**RC250077 SANDY POINT ALLUVIAL GOLD MINE
REQUEST FOR FURTHER INFORMATION – NOISE**

Our responses reference our report *Sandy Point alluvial gold mine – Noise Assessment* (Rp 001 20250974, 5 December 2025), referred to below as the ‘assessment report’.

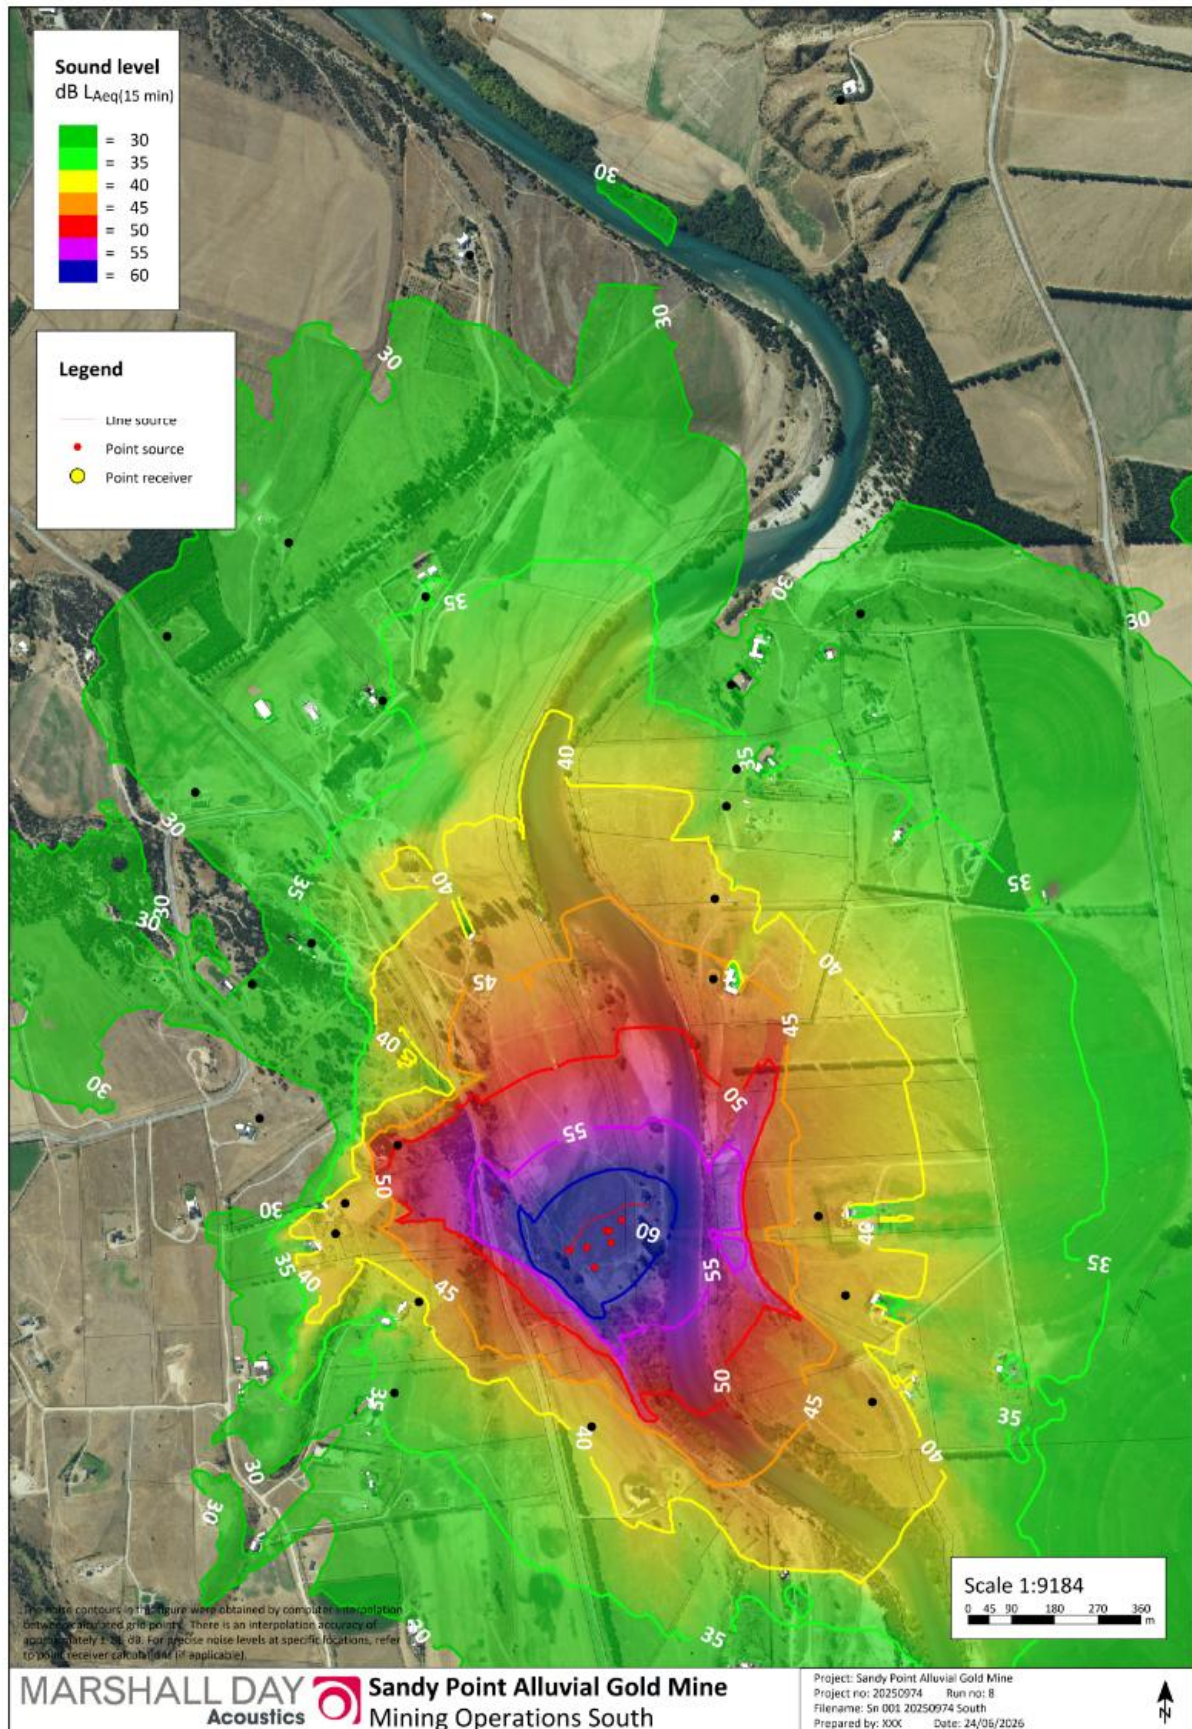
2. The MDA report fails to address the effects over land that could be developed as provided by either the CODC or QLDC District Plans. The MDA report should be updated to include an assessment of the noise effects over land that could reasonably be developed so that the effects on neighbouring landowners and their ability to use their land in the way the Plans provide for can be assessed. I consider that this could easily be done by showing the predicted noise level contours for the three scenarios in the MDA Report and the additional scenarios described below, and by clearly showing the noise levels over vacant land and land where the District Plan provides for or anticipated further residential development.

As part of the additional noise modelling, we have undertaken in response to item 3. below, we have developed noise contours showing that predicted noise levels over this site would exceed the daytime noise limit at a small part of one of these sites but would comply at the other sites. The figure below shows the predicted noise contours at the “Unidentified Lot on Tarras-Cromwell Road (SH8)” indicating a predicted exceedance of the 55 dB L_{A10} noise limit at the northern end of the site by 1-2 decibels.

This relatively small exceedance is only predicted when activity is at the closest location to this site. We understand that this would be near the beginning of the proposed mining sequence, which is proposed to be for three years in total. Therefore, given there is currently no dwelling on the site (nor are we aware of a consent to build one), the likelihood of a dwelling being established in this specific area of the site before the mining activity is undertaken is relatively low and if it was, the noise effects would be temporary. Based on this, we consider that the proposed noise levels and effects are both acceptable and reasonable.

A2 Mining operation south A

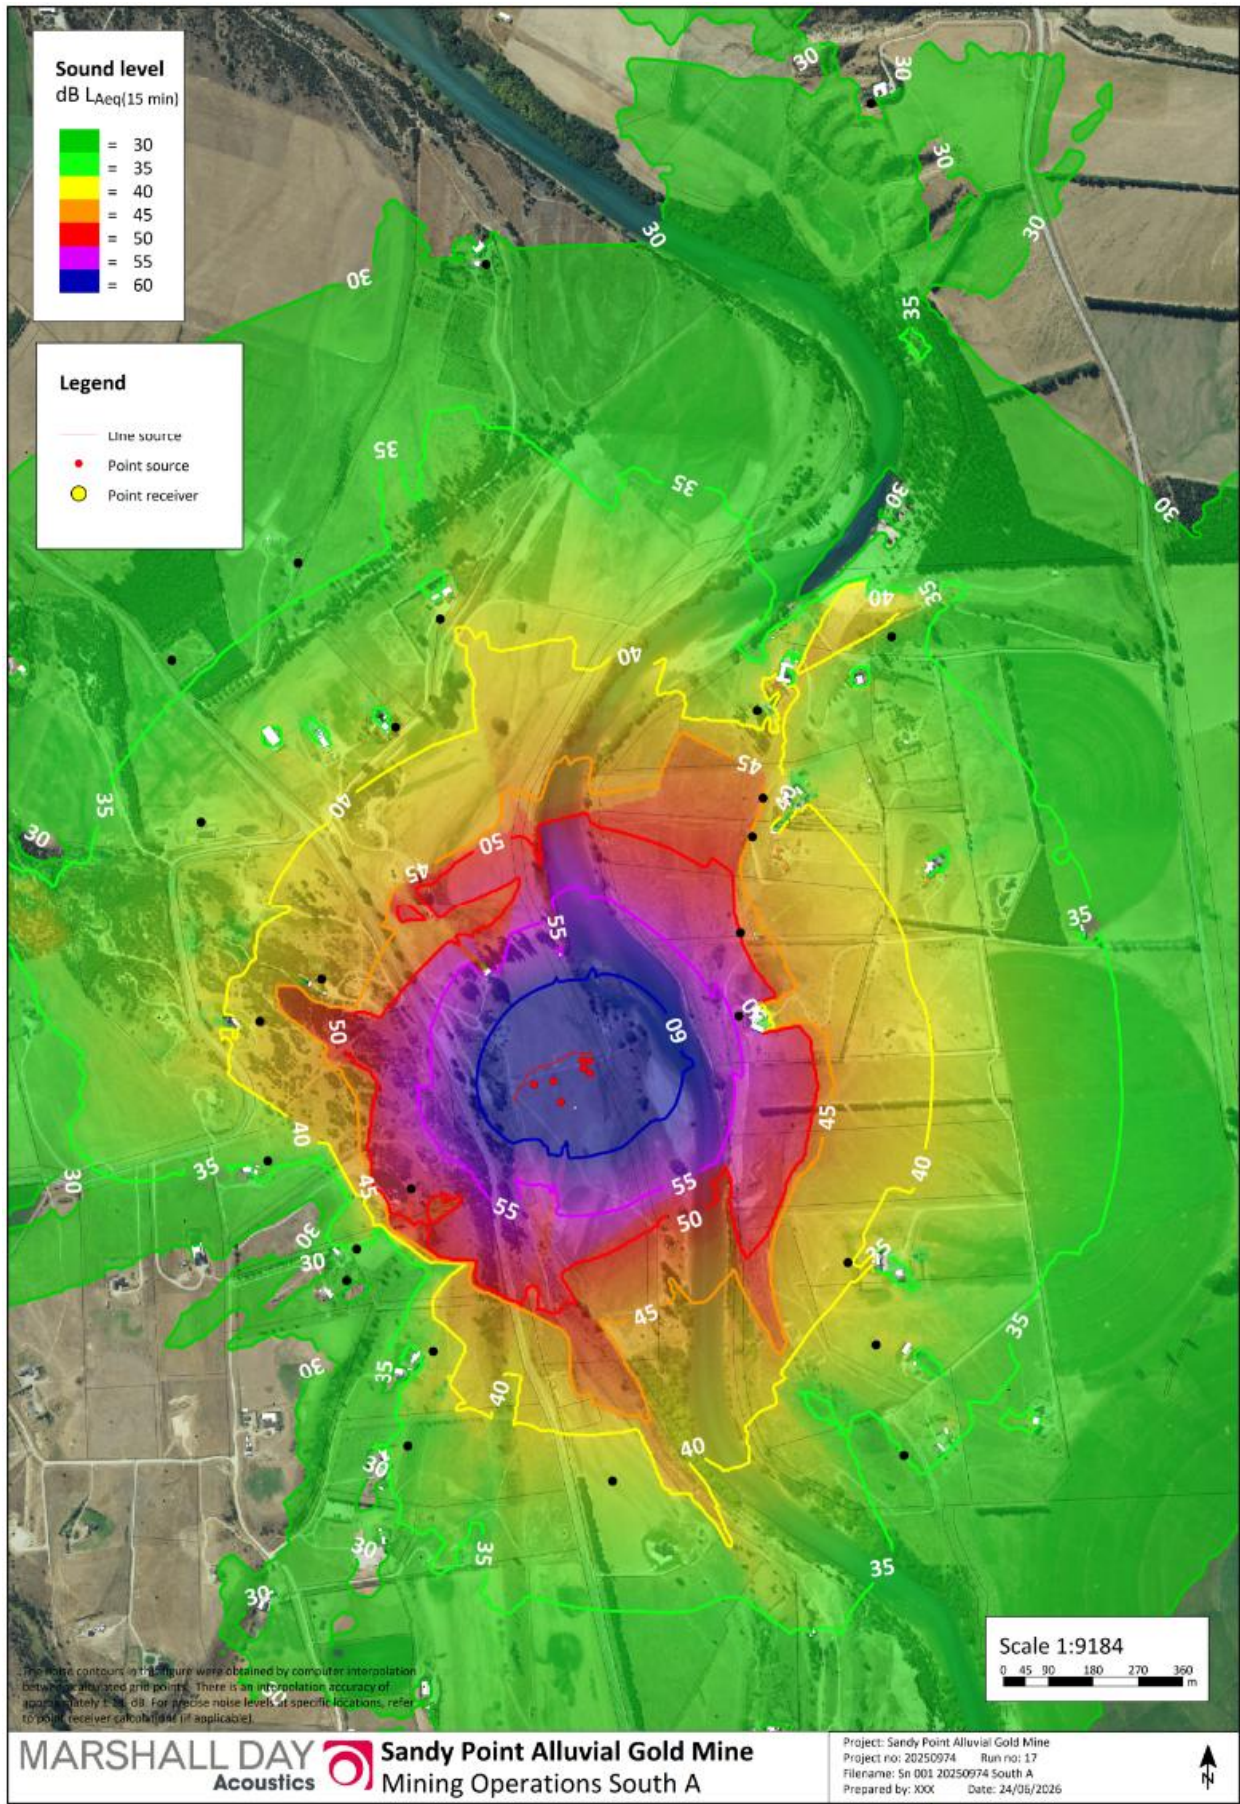
I recommend that the scenarios in the MDA Report are supplemented with noise level predictions for the scenarios set out below in yellow circles (reproduced Figure 3 of MDA Report).

We have modelled the additional locations recommended by the peer reviewer, with all plant at ground level — the worst case for both proximity and screening at the surrounding dwellings. This also addresses the concern raised in Item 5. below regarding the depth of the pit used for noise modelling. Noise contours from these additional modelling scenarios are shown in Appendix A.
